TO: Application G- 16751
FROM: GW: *Van Ball*
(Reviewer's Name)
SUBJECT: Scenic Waterway Interference Evaluation

PUBLIC INTEREST REVIEW FOR GROUND WATER APPLICATIONS

SUBJECT: Application G- 16751 Supersedes review of na Date of Review(s)

A. GENERAL INFORMATION: Applicant's Name: Amy Woodruff County: Harney

G-16751 Woodruff 25S/31E-06

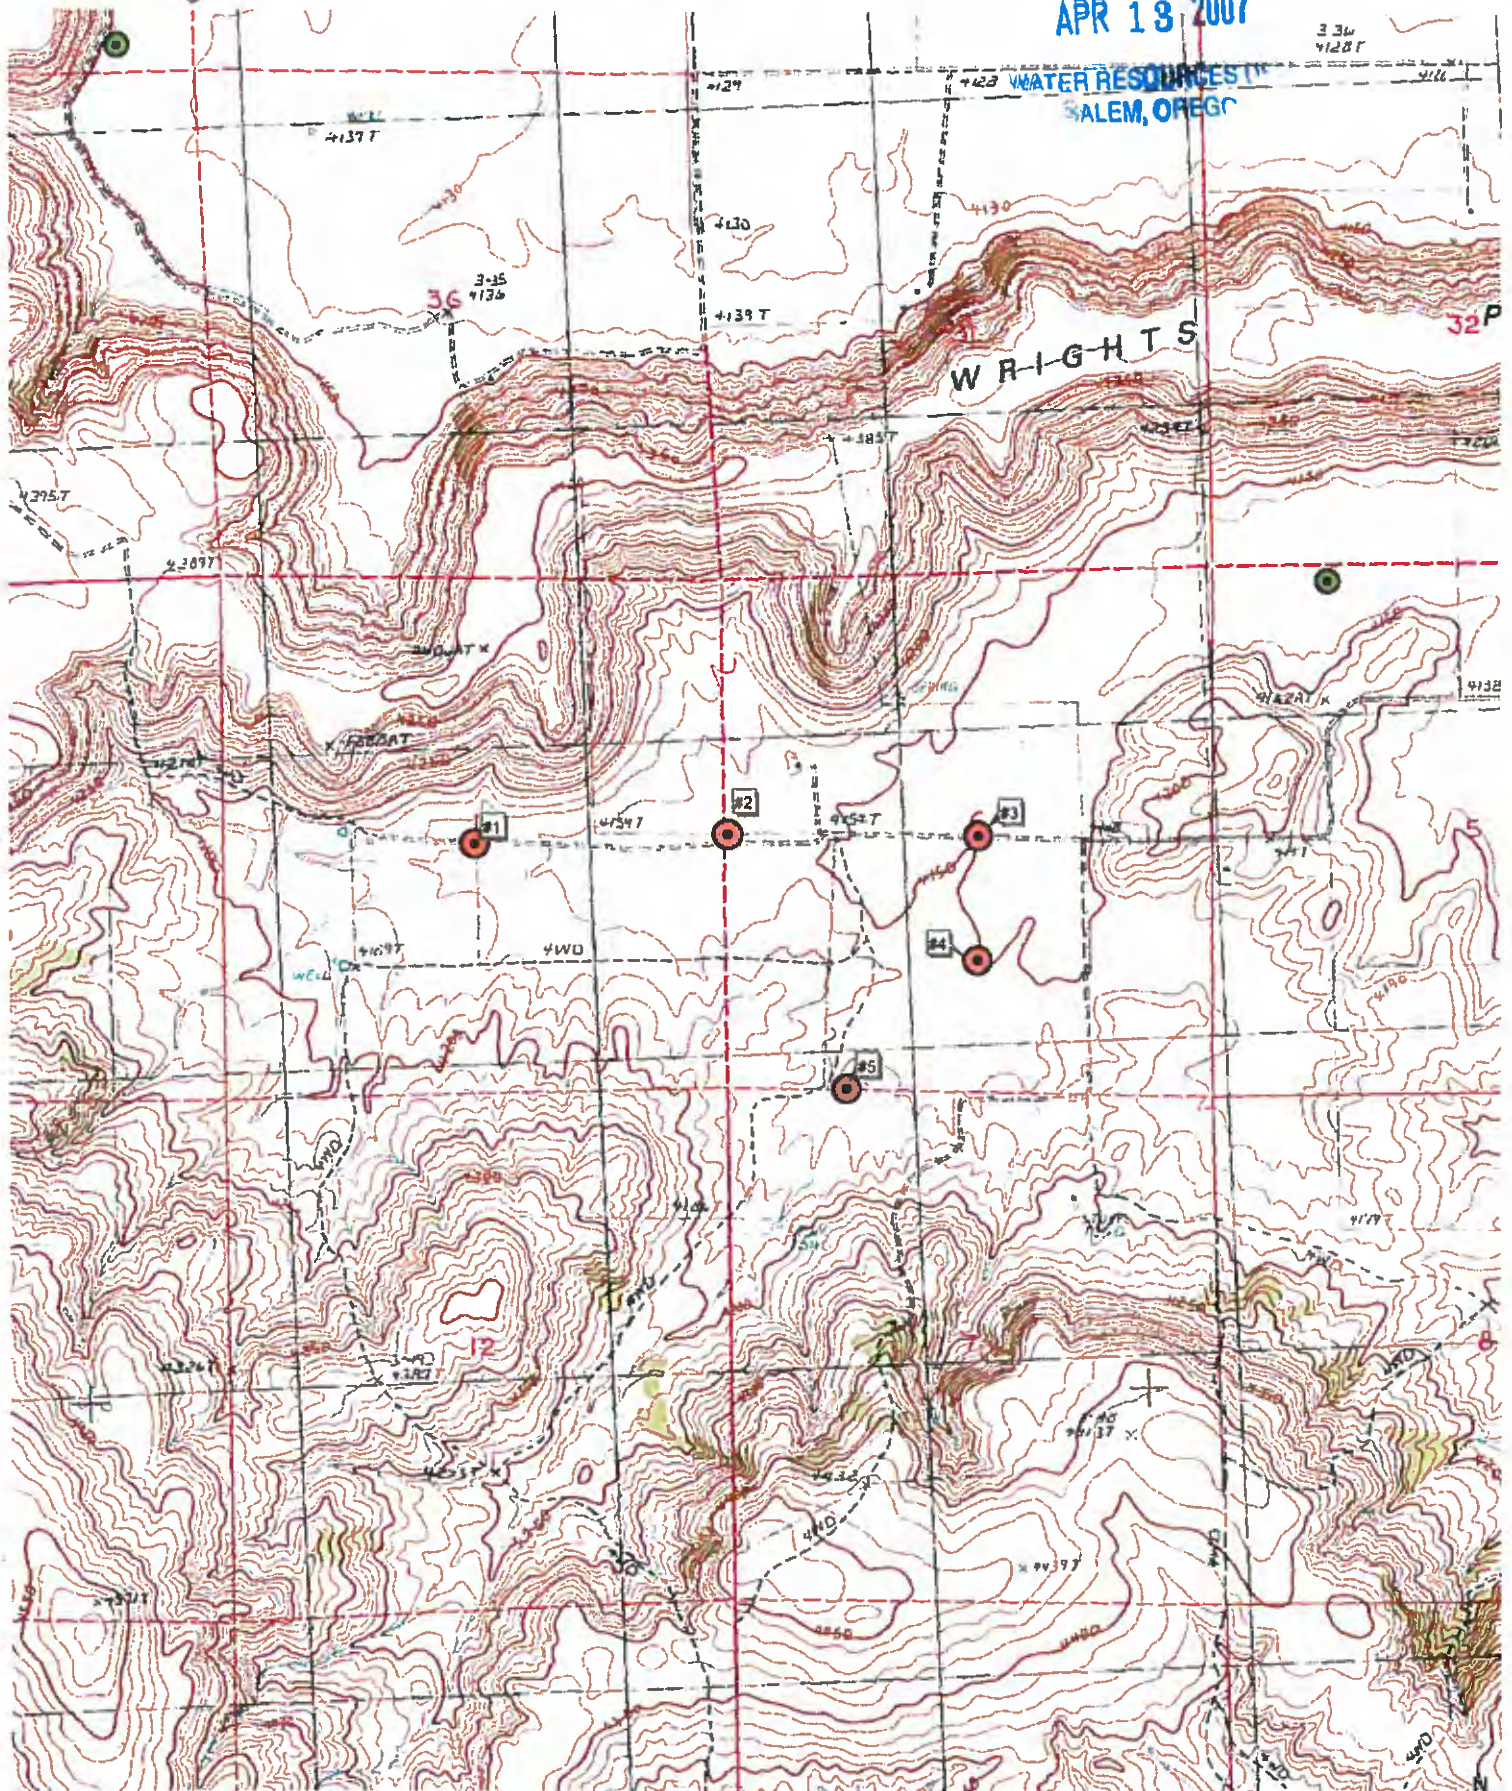
The two wells are located immediately south of Wrights Point, a lava-filled valley remaining today as a topographic high after softer material was eroded away. Surficial deposits at the site are mapped as Qa (alluvium along streams), and are bordered immediately on all sides and below by Tvs, a Pliocene sequence of volcanic, pyroclastic, and sedimentary rocks. The alluvial deposits consist of fine- to coarse-grained material, generally being coarser near the valley margins and fining towards the valley center. At this site the alluvial sediments are limited in extent. There are no well logs in GRID for 25S/30E-01, and only 6 well logs in 25S/31E-06 (attached). Data from these well logs gives alluvial thickness ranging from 20 to over 200 feet. The proposed well construction will have the wells likely completed in both the alluvium and underlying Tvs rocks. The degree of confinement likely increases with depth. Limited well log data in the area suggest the alluvial aquifer is more unconfined than confined. HARN 1111 reports a well yield of 500+ gpm. It is unlikely that any single well will yield the 3.34 cfs rate. A limited understanding of the flow system suggests a fair degree of hydraulic connection between the alluvial material and the underlying Tvs unit.

HARN 874 Hydrograph
Land Surface Elevation = 4124 feet

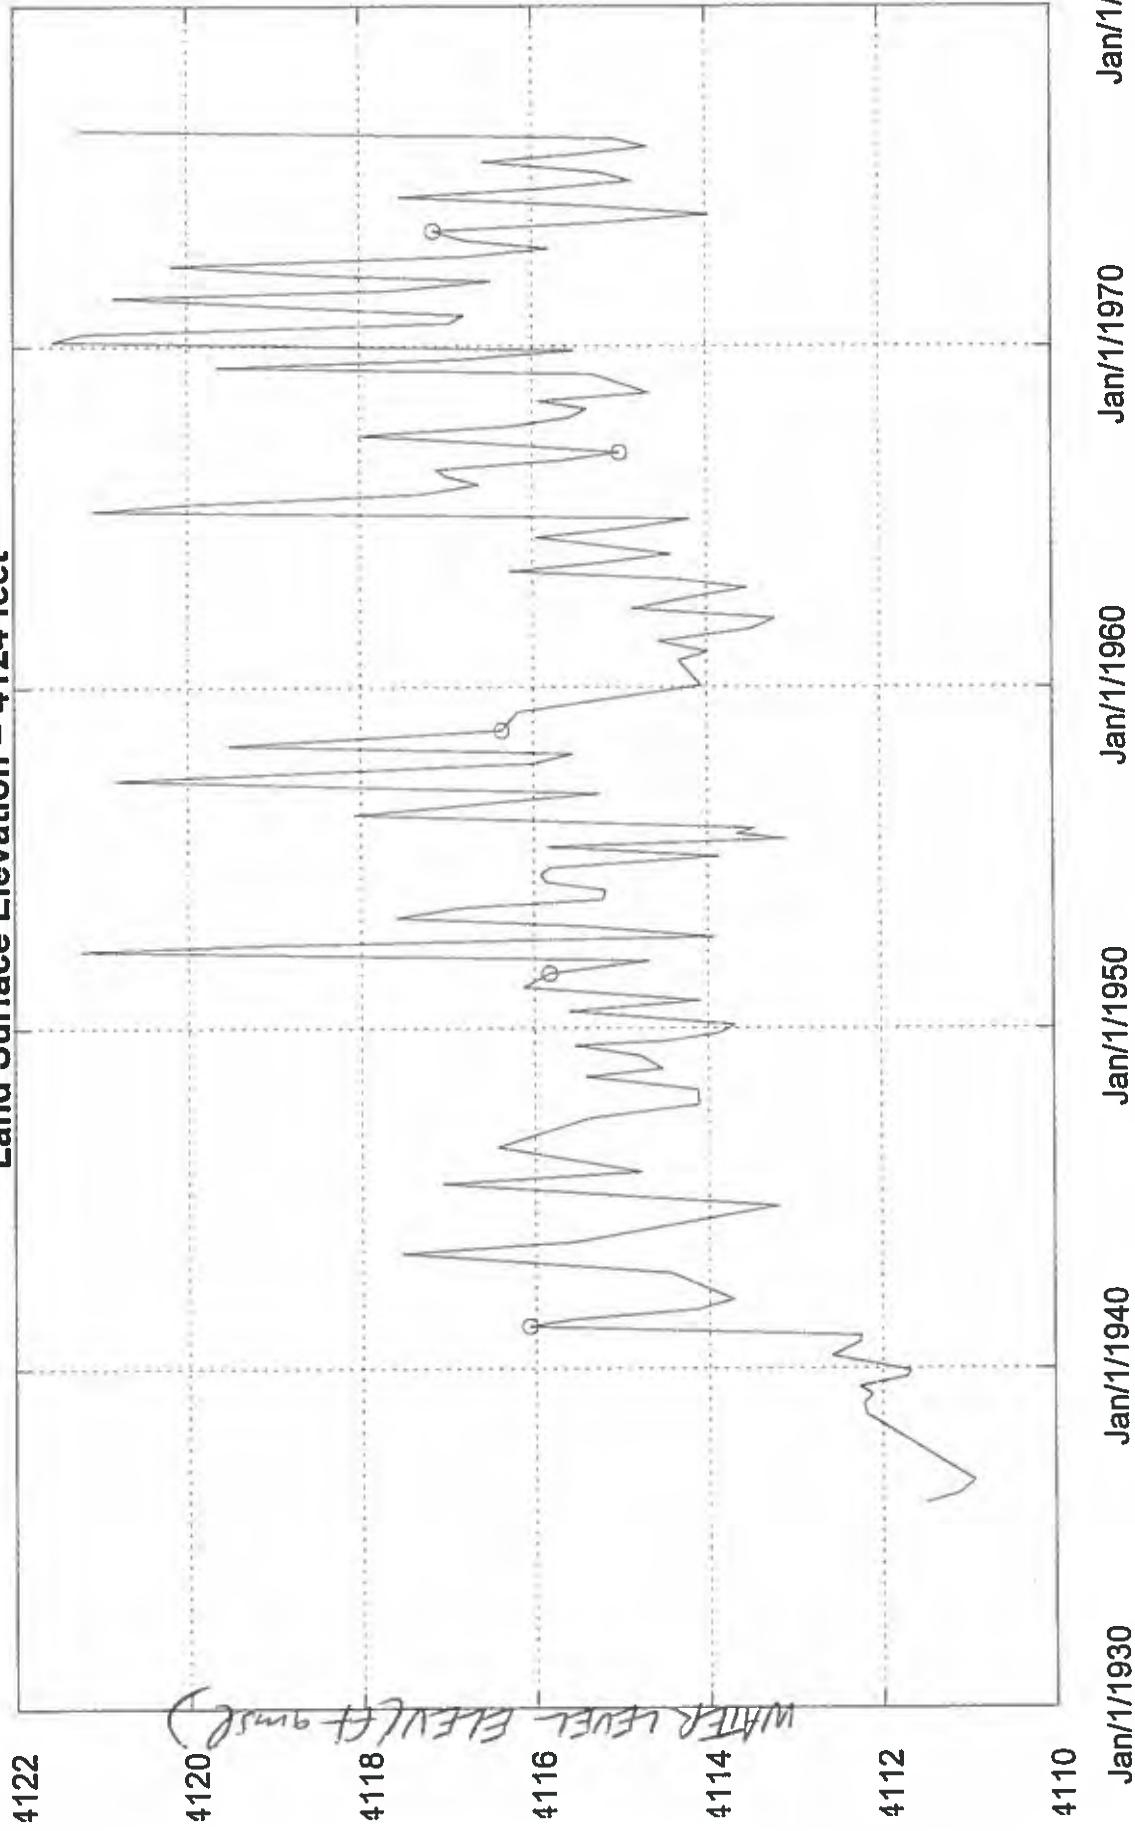
There are data from old state observation well HARN 874 located in section 28 NE of this applicant's wells. Water levels fluctuated from 2-10 feet below ground from 1930-76; no recent data have been collected at this well.
